TEXAS 32 FEE

**SUNDRY NOTICES AND REPORTS ON WELLS**

CIMAREX ENERGY CO. OF COLORADO

Texas 32 Fee #7  
2310' FNL & 330' FWL  
Sec 32 - T18S - R26E  
Eddy Co NM  
API # 30-015-39107  
GL: 3412' KB: 3430'

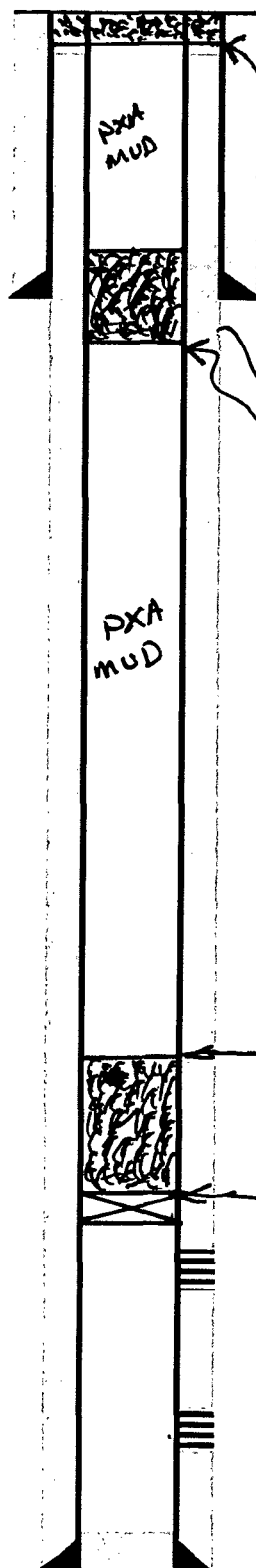
- PERF 1) SET 5-1/2" CIBP @ 2,450'; PUMP 25 SXS. CMT. @ 2450'-2280' (T/GLOR.); CIRC. WELL W/ PXA FLUID. - WOC & TAG  
2) ~~PUMP~~ 30 SXS. CMT. @ 1,001'-810' (8-5/8" CSG. SHOE, T/S.A.); WOC X TAG CMT. PLUG.  
3) PERF. X CIRC. TO SURF., FILLING ALL ANNULI, 25 SXS. CMT. @ 63'-3'.  
4) DIG OUT X CUT OFF WELLHEAD 3' B.G.L.; WELD ON STEEL PLATE TO CSGS. X INSTALL DRY HOLE MARKER.

PERF. X CIRC. 25 SXS. @ 63'-3'

PERF @ 1000'-SQ - WOOD TAG

Pump 30 SXS. @ 1001'-810' - TAG

Pump 25 SXS. @ 2450'-2280''

SET 5 1/2" CRBP @ 2450'

Approved for plugging of well bore only.  
Liability under bond is retained pending receipt  
of C-103 (Subsequent Report of Well Plugging)  
which may be found at OCD Web Page under  
Forms: www.ogm.state.nm.us/oed.

WELL MUST BE PLUGGED BY 2/20/18
